# DANE COUNTY DEPARTMENT of PUBLIC WORKS, HIGHWAY and TRANSPORTATION

### RFB NO. 109054 - ADDENDUM NO. 1

## PUBLIC SAFETY COMMUNICATIONS CENTER INFRASTRUCTURE UPGRADES - AIR HANDLING EQUIPMENT

Sheet No.  
**H1.1**

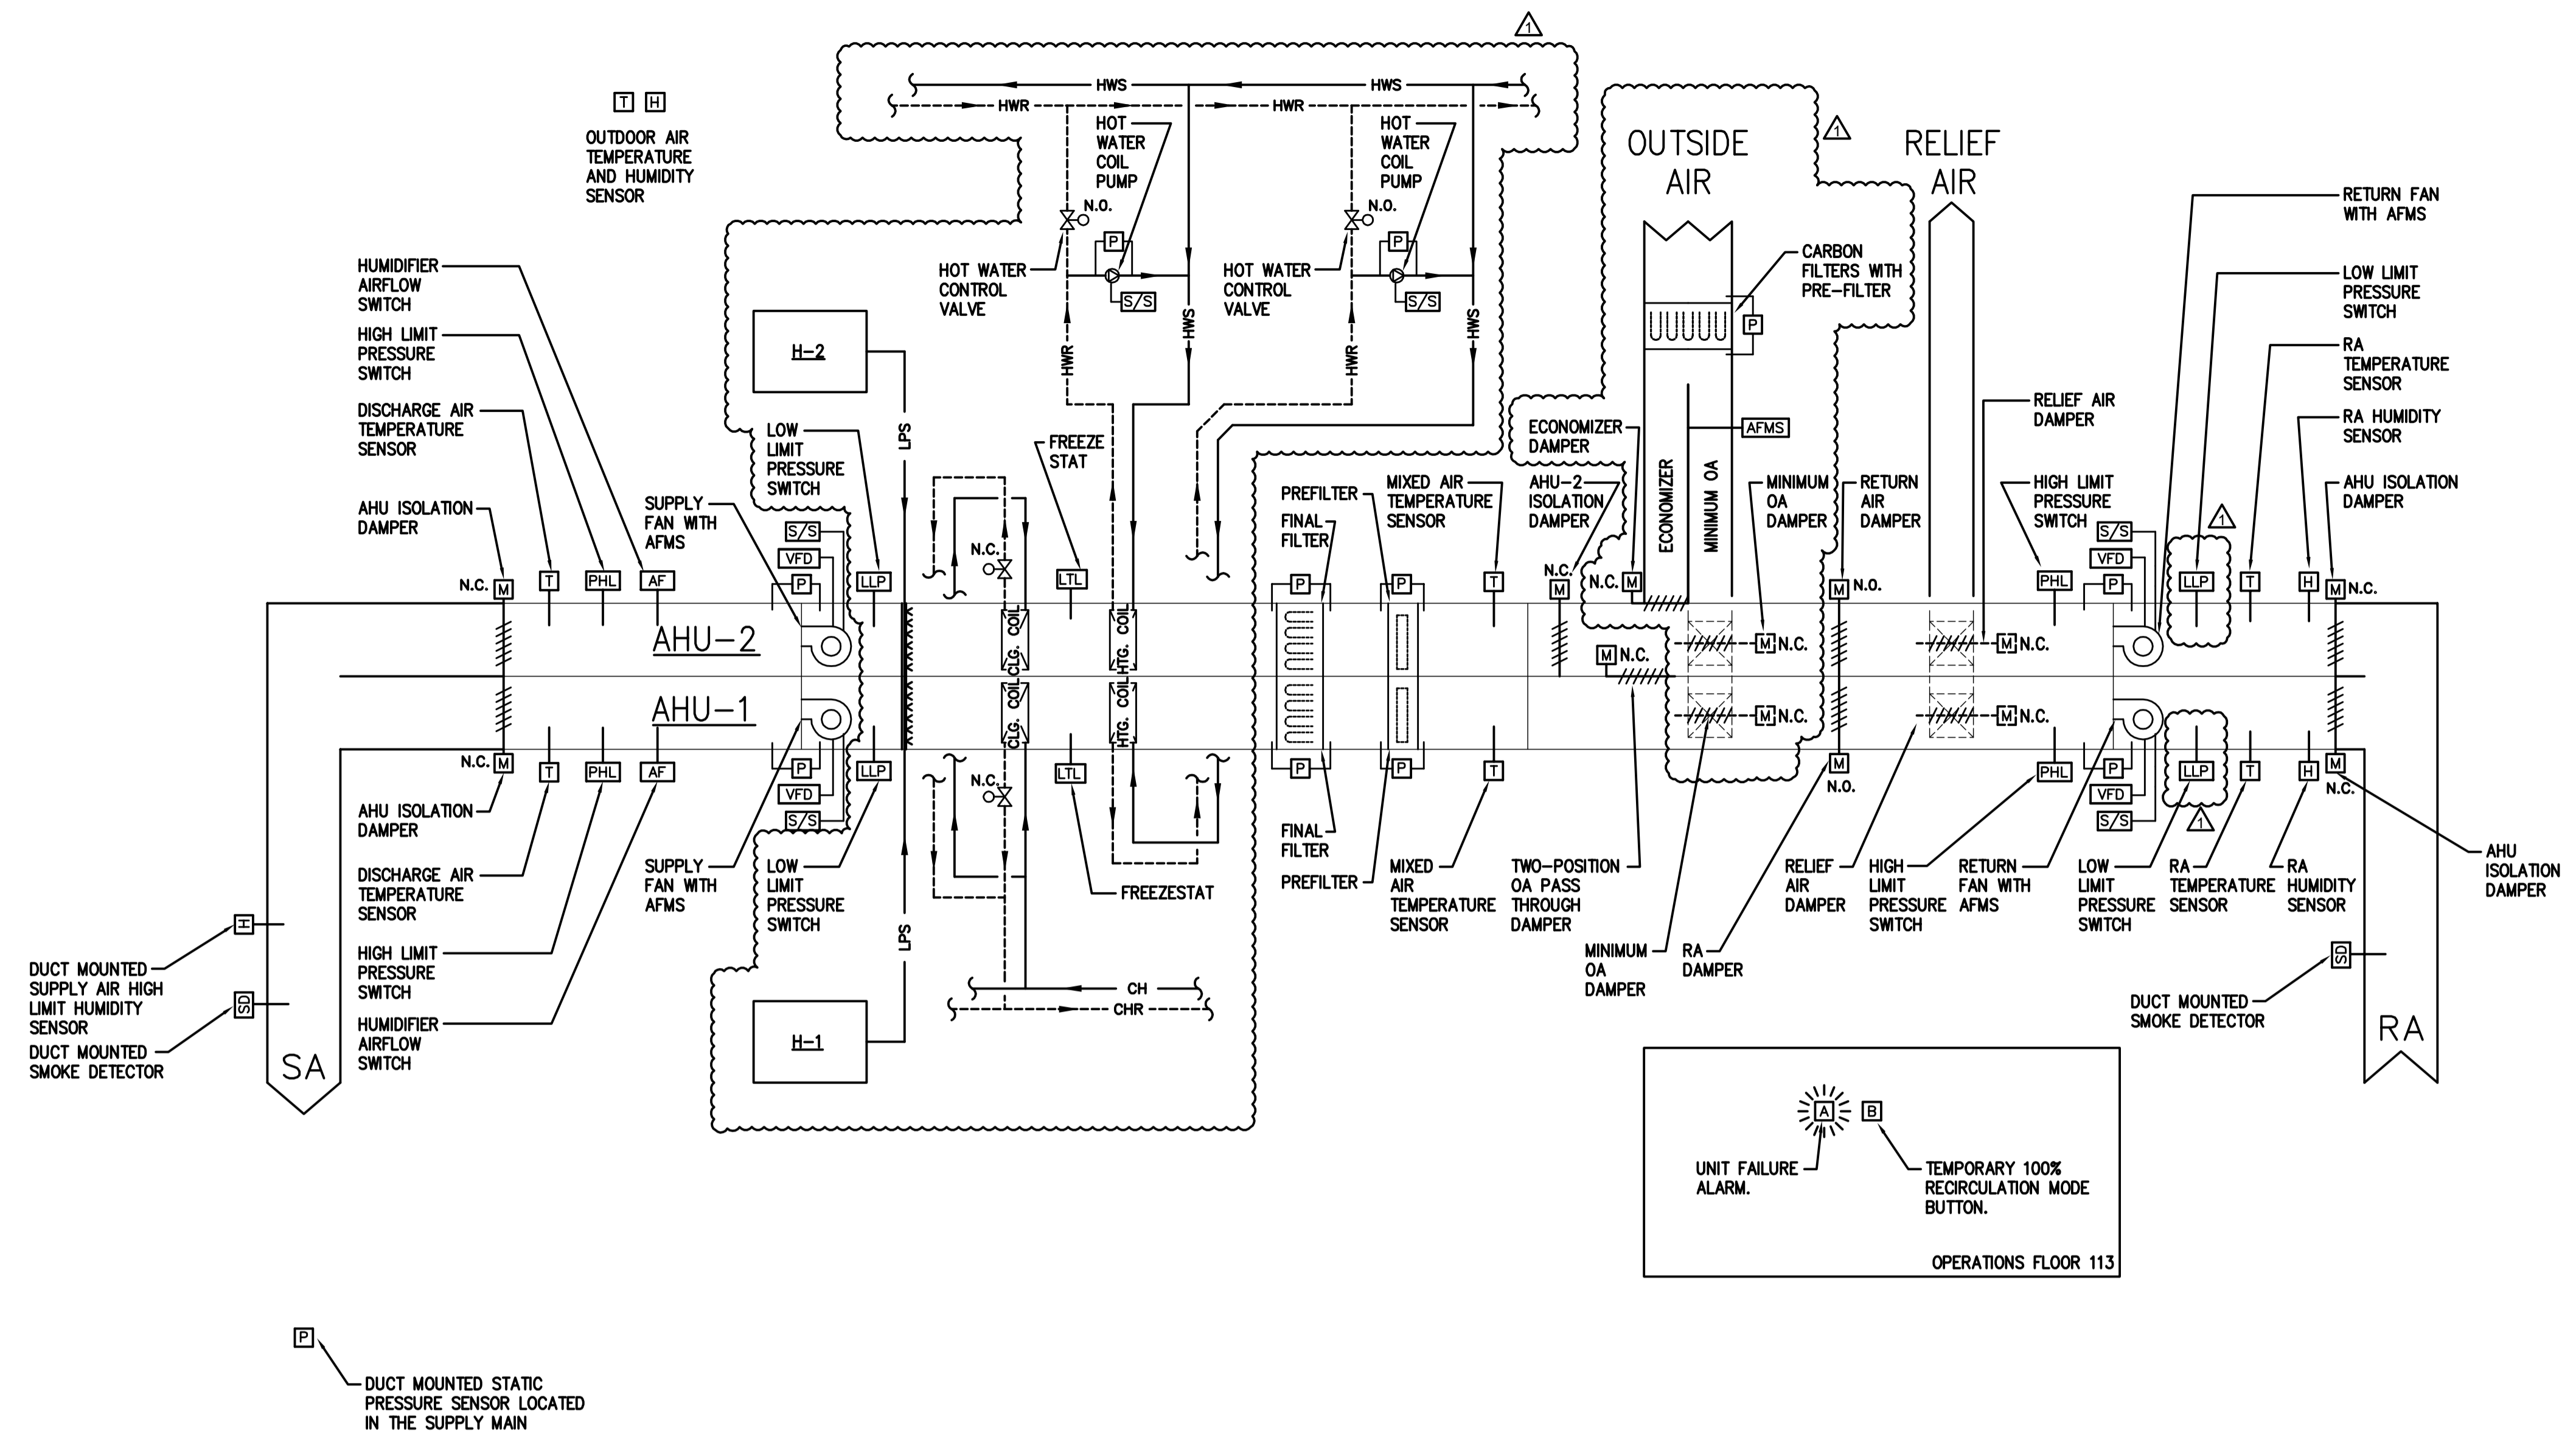
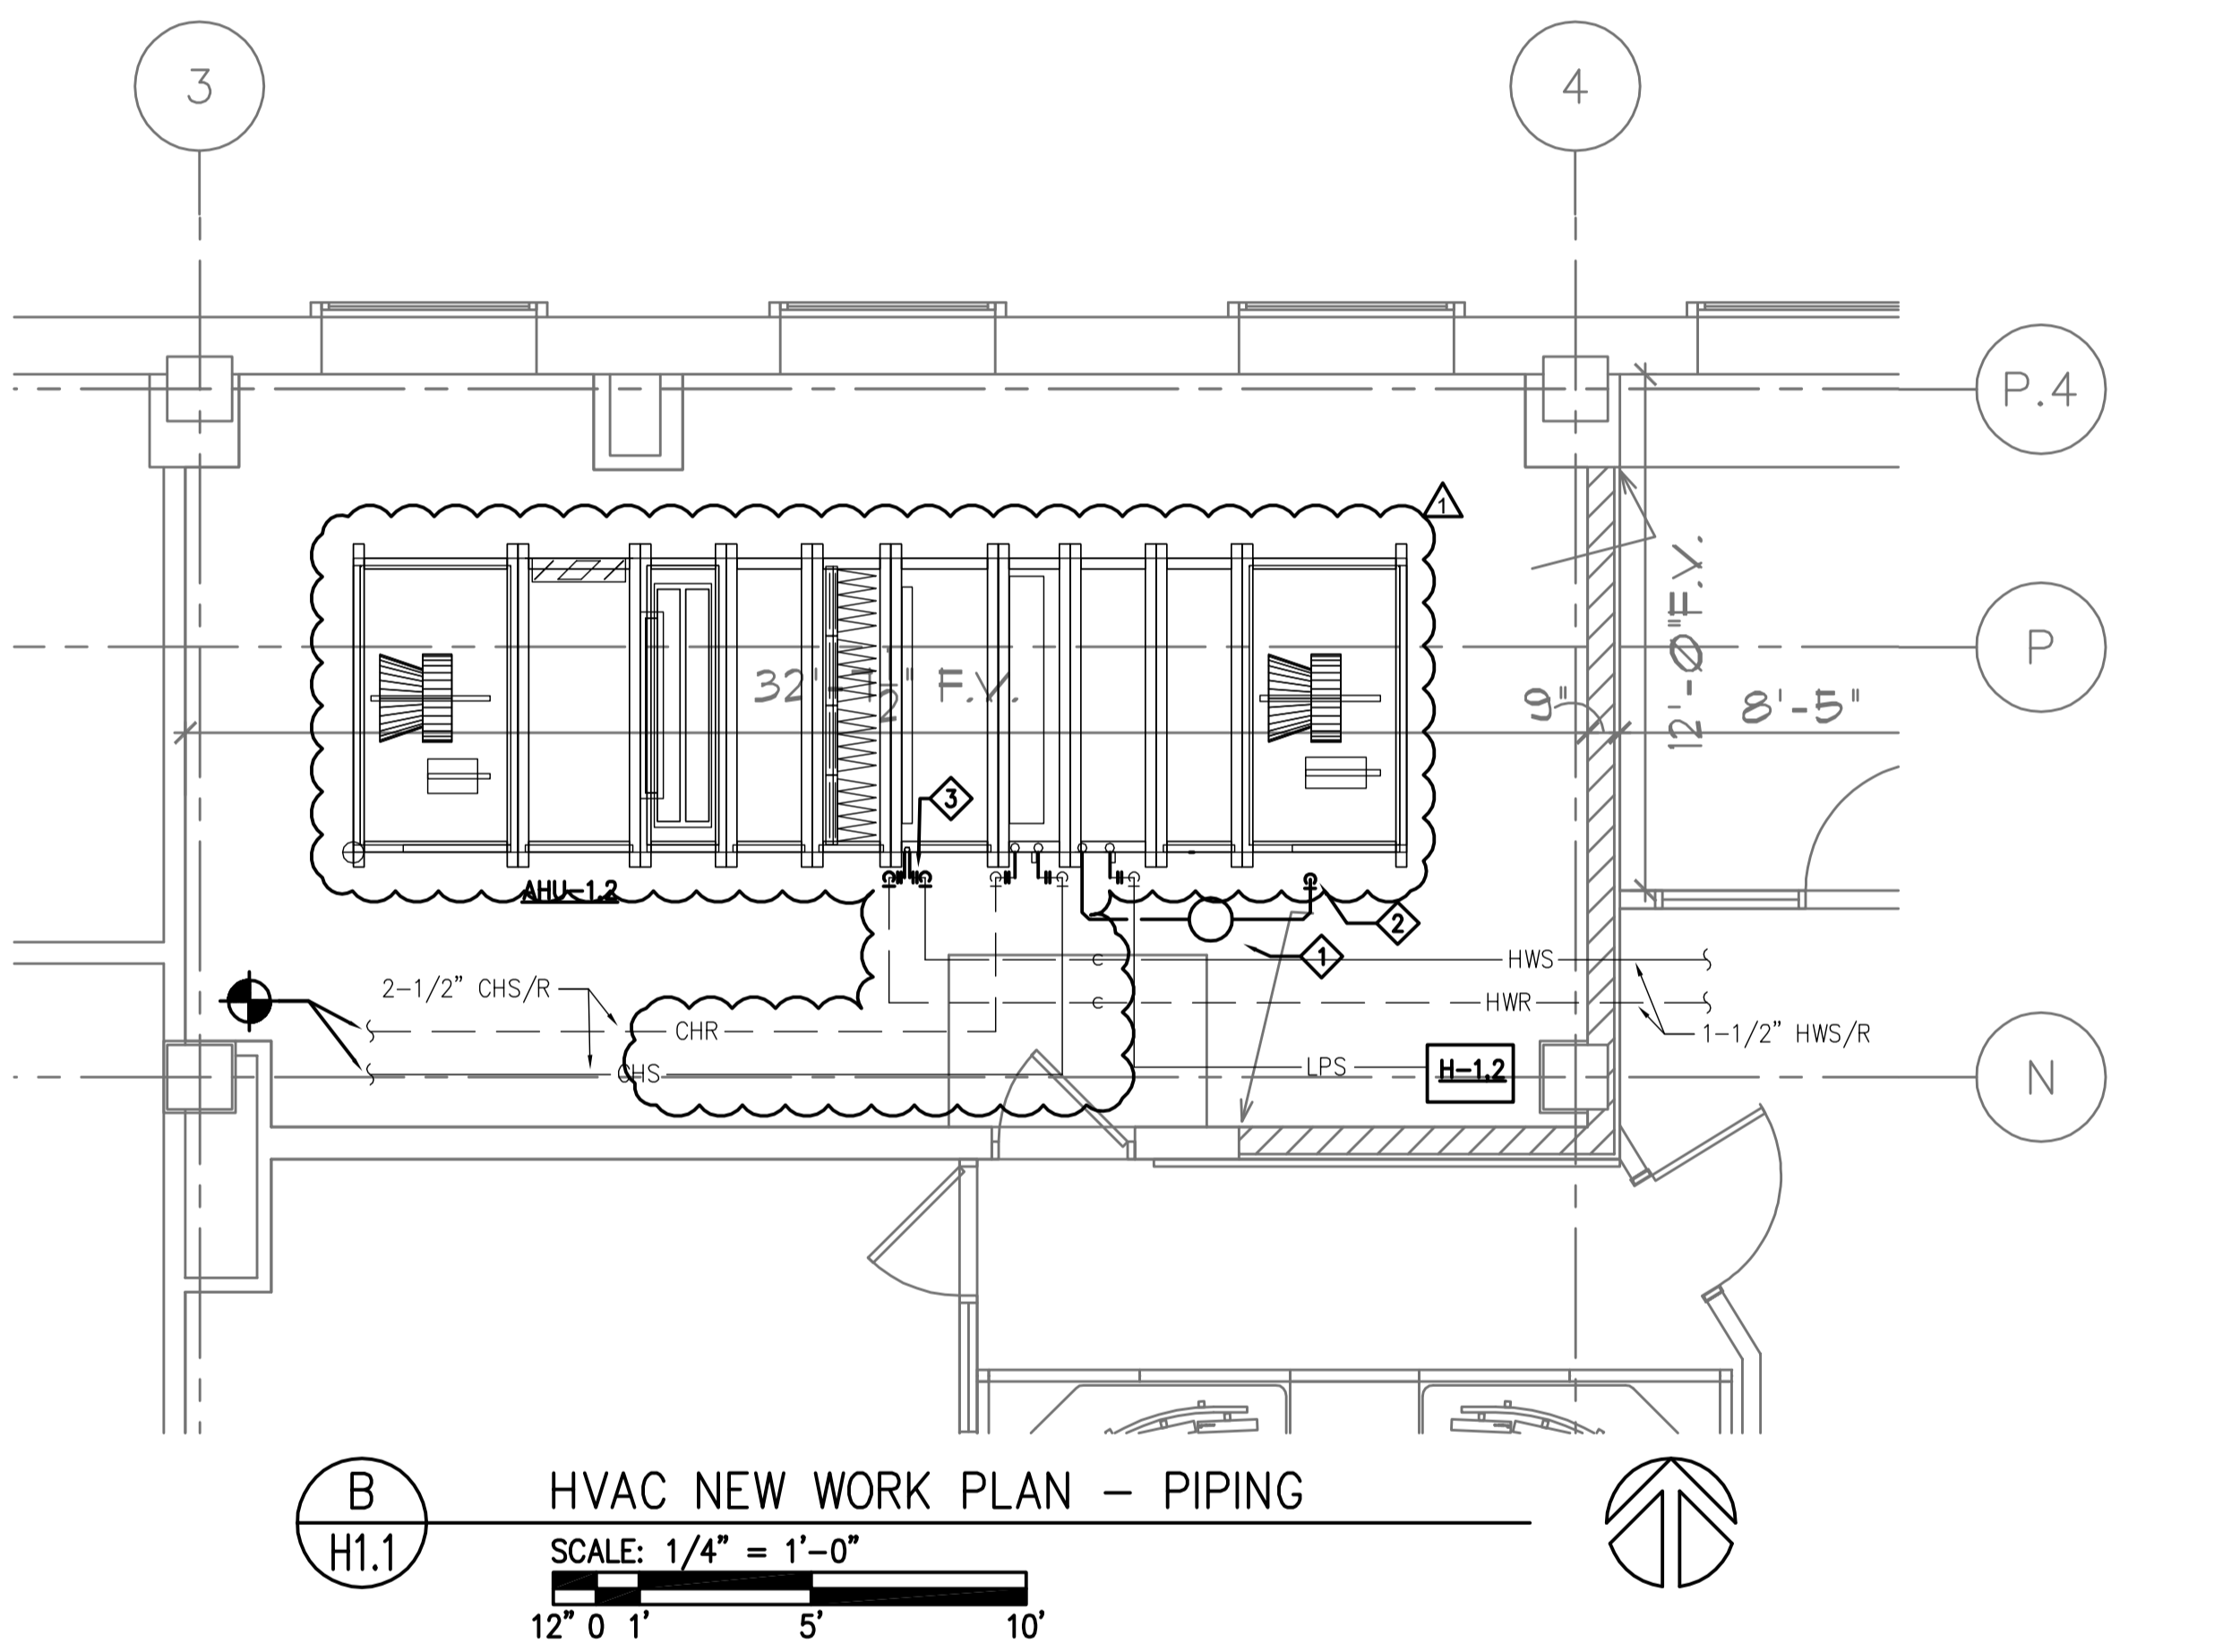
**7. Sheet H1.1**

Delete current Sheet H1.1; replace with new Sheet H1.1, issued with this Addendum.

- Switched from single heating / cooling coil to separate heating and cooling coils;
- Added isolation damper after supply fan;
- Clarified dampers are to be provided by manufacturer;
- Added isolation damper to AHU-2 after outdoor air section;
- Changed filter type;
- Changed disconnect provider;
- Added steam generator and dispersion tubes to General Note;
- Removed ‘Premanufactured curb’ note from AHU schedule;

- Added notes 10 and 11 to AHU schedule; and
- Changed from centrifugal to plenum fans.
